Attachment 2  
BYE-69318-66  
*cy 1*

ITEK EVALUATION SUMMARY

Attachment 2  
BYE-69318-66ITEK EVALUATION SUMMARYRating Category I: PERFORMANCE EVALUATIONRating: 4.0

ITEK  
CURVED PLATEN DEFOCUS EFFECT

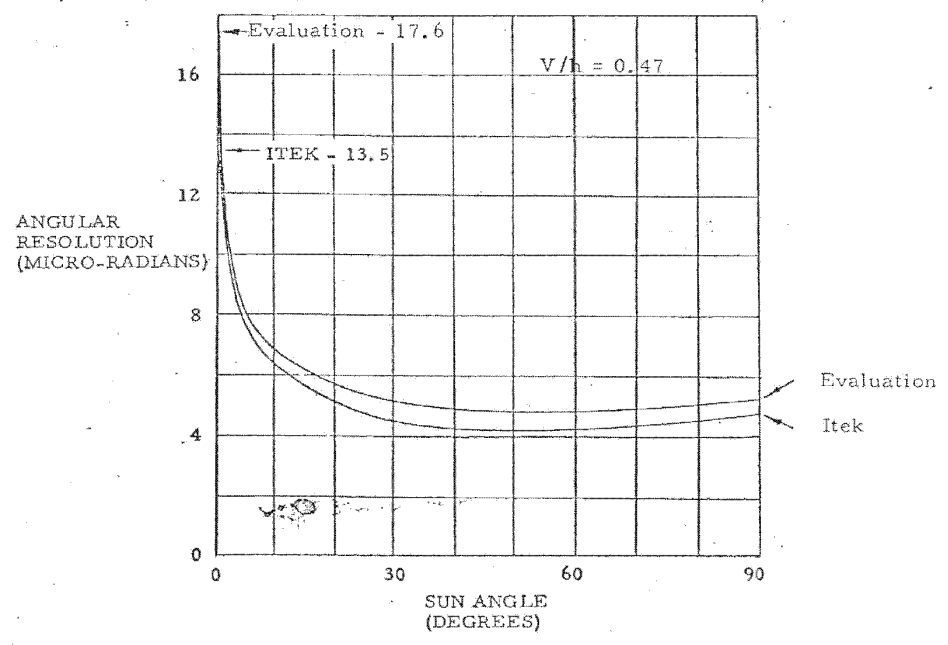
There are two added effects operating in the proposed system which have a significant impact on the system performance. The first of these is defocus due to drum curvature. While the contractor did recognize this problem, he did not examine its impact across the entire operating envelope. In particular, the low sun angle-high V/h resolution data presented by the contractor apparently does not include any allowance for this image degrading source (see Figures I and II).

In addition, as noted above the low sun angle/high V/h performance of the system is seriously degraded by the curved drum effect. In view of this behavior the operational utility of the camera system will be seriously impaired for some operating conditions.

ITEK  
NADIR RESOLUTION VS. SUN ANGLE

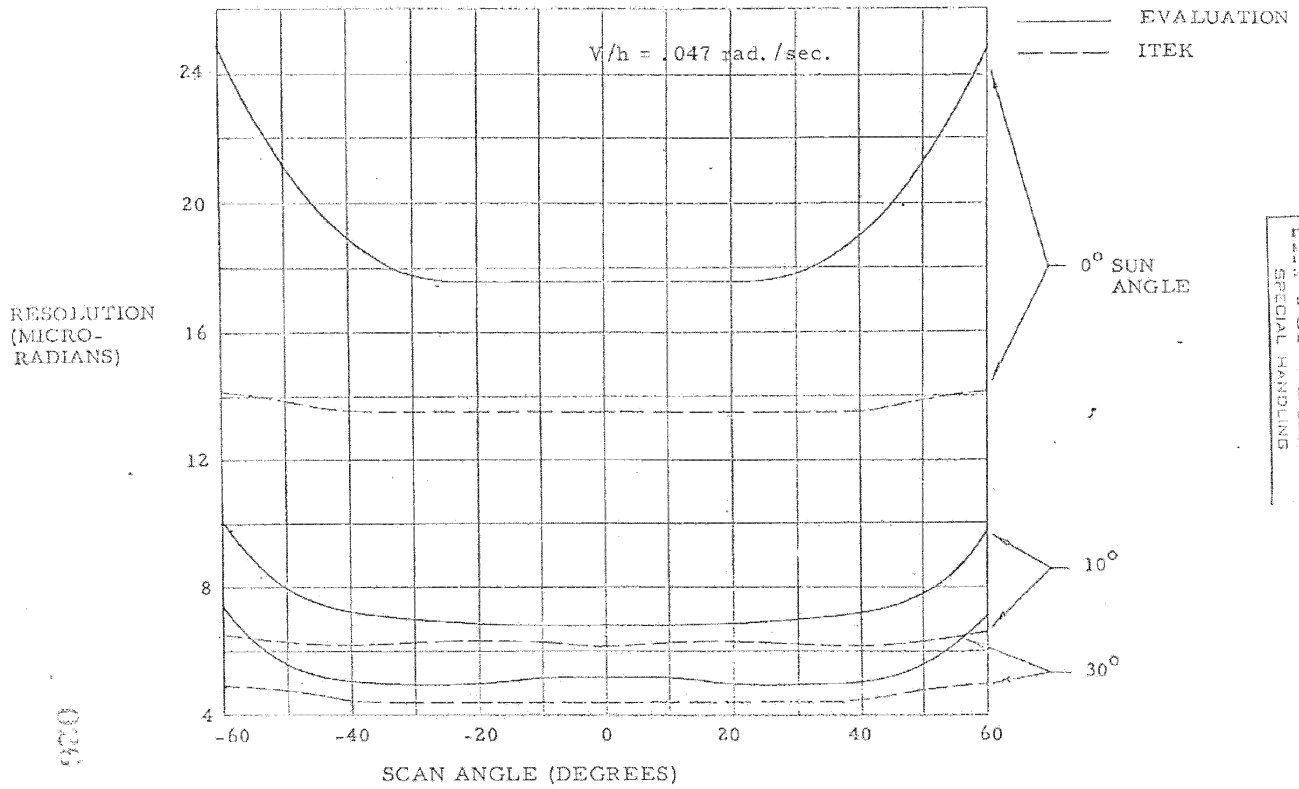
Figures II, III and IV together summarize the resolution performance of the contractor's system and compare the contractor's claimed performance with the Evaluation Group's assessment. The Evaluation Group's estimation of performance does not take into account any potential image quality degradation due to high scanning mirror incidence angle or veiling glare and assumes that a number of performance deficiencies in the design as proposed can be rectified. These are discussed in more detail below.

CAMERA SUPPORT STRUCTURE AND SUPPLY SPOOL ARRANGEMENT

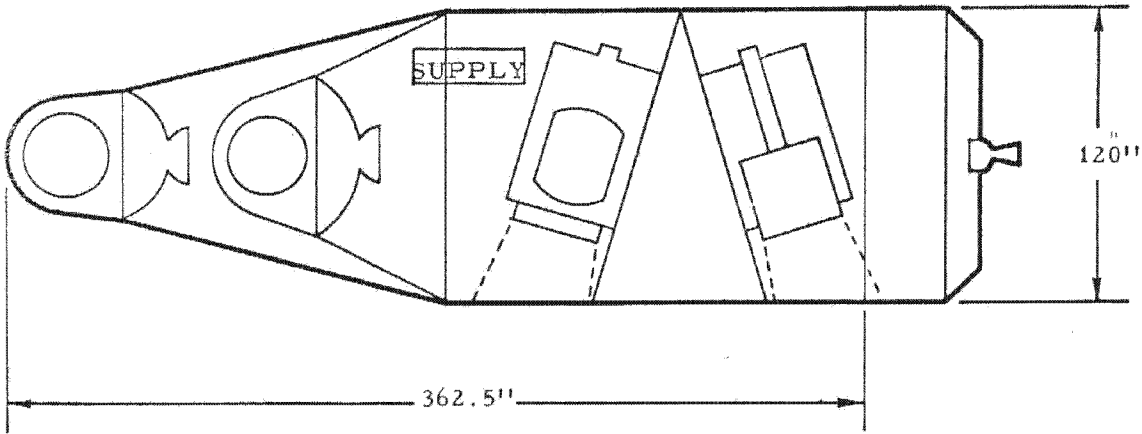
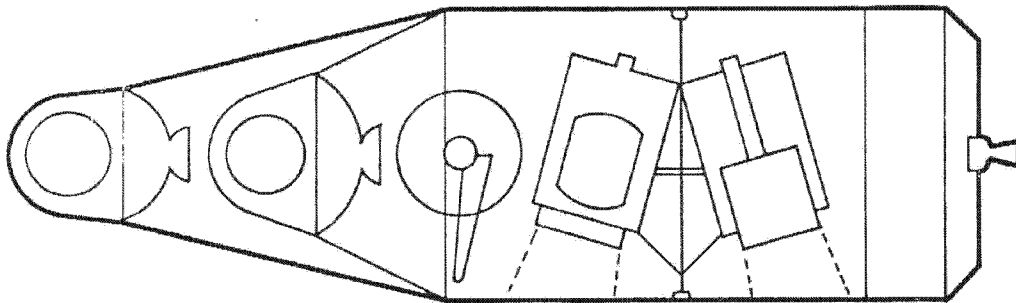
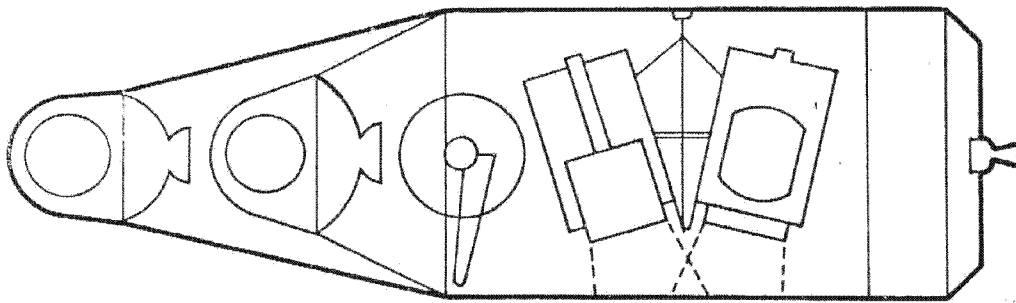
The contractor also proposed that the two cameras be individually mounted to the SBA and that the supply spools be oriented along the vehicle yaw axis and near the top of the Space Vehicle for easy access. (See Figure VA)

During the course of the evaluation, an alternative camera arrangement was examined which alleviated some of the space vehicle structural difficulties (see Figure VC). This rearrangement eliminates the requirement for skewing the viewport cutout along the space vehicle and reduces the total area of the external doors. In addition, it is possible if necessary to frame these doors so that they need not be load-carrying during launch; but, even with this configuration, the structural problems implied by the camera viewport requirements are substantial and have adverse effects on the space vehicle.

The supply spool location as proposed by the contractor (see Figure VA) results in appreciable space vehicle center of gravity shift as the film moves from the supply to the take-up spools. There appears to be no camera associated reason why the spools cannot be relocated as shown in Figure VB. The evaluation was conducted with the assumption that the supply spools would be relocated.

The method proposed by the contractor for mounting the cameras separately into the space vehicle results in poor control of inter-camera alignment. Consequently, it was judged necessary to add an inter-camera

structure as depicted in Figure VB. In any case, this is probably more economical from a structural weight point-of-view than the configuration proposed by the contractor.

ITEK  
VIEWPORT DOOR AND THERMAL CONFIGURATION

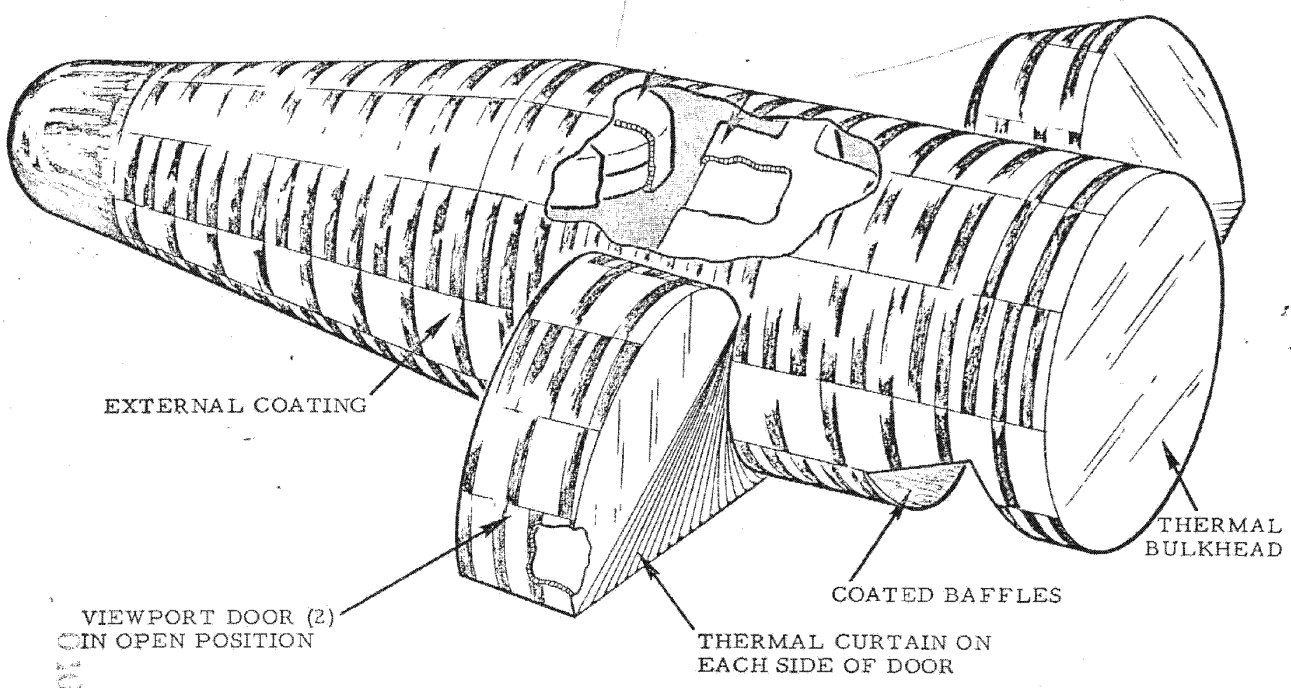
The operating doors for thermal protection as proposed by the contractor are large clam shell sections (see Figure VI). During door open times, the optical system must be thermally protected by side curtains which fold out as the doors open. When the doors are open, the frontal area of the space vehicle is approximately doubled. This arrangement (particularly in view of the folding curtains) will be difficult if not impossible to implement. An alternative mechanization of these doors may be possible although none was identified during the course of the evaluation. The reliability impact of the requirement for operating doors was not included in the camera reliability computation. Good design should minimize door reliability problems, but they have historically been a source of difficulty.
